Ref: FCC Class II Permissive change for FCC ID: 2BBYH-C1018

Applicant: Creek Wearable Technology Co., Ltd.

This is to request a Class II Permissive change for FCC ID: 2BBYH-C1018 originally granted on 2023-07-20 (date).

CW Watch S1变更前心率板
CW Watch S1 Pre-Modification Heart Rate Board

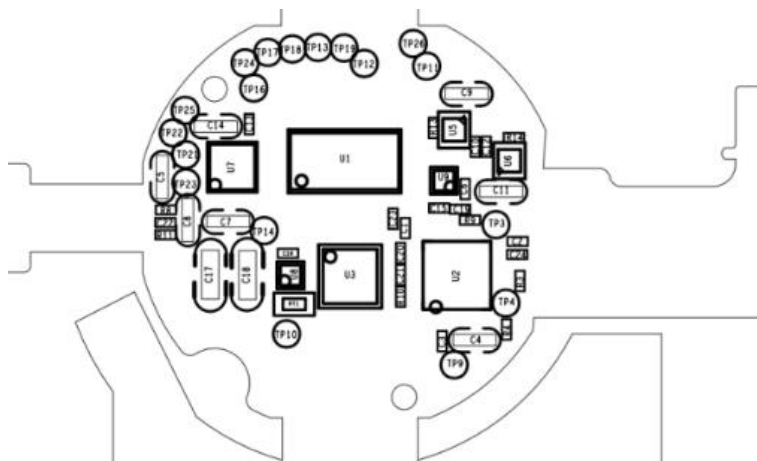
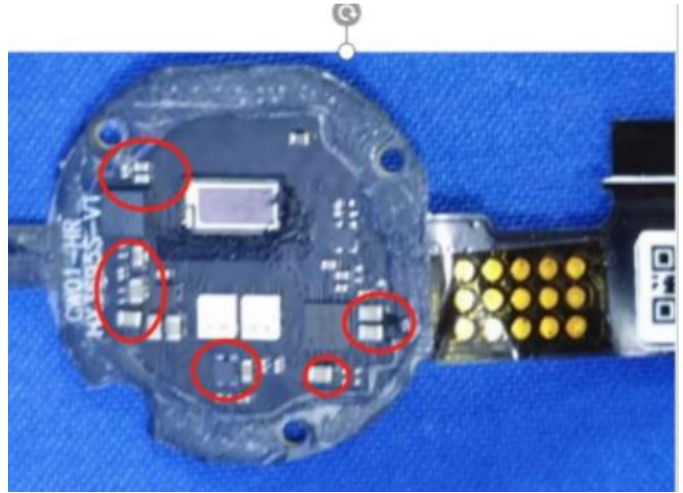
- 1, Heart rate board added program material IC.HX3695S, alternative program 1 material,
2. The heart rate board added D3 and D4 to replace the original U3.
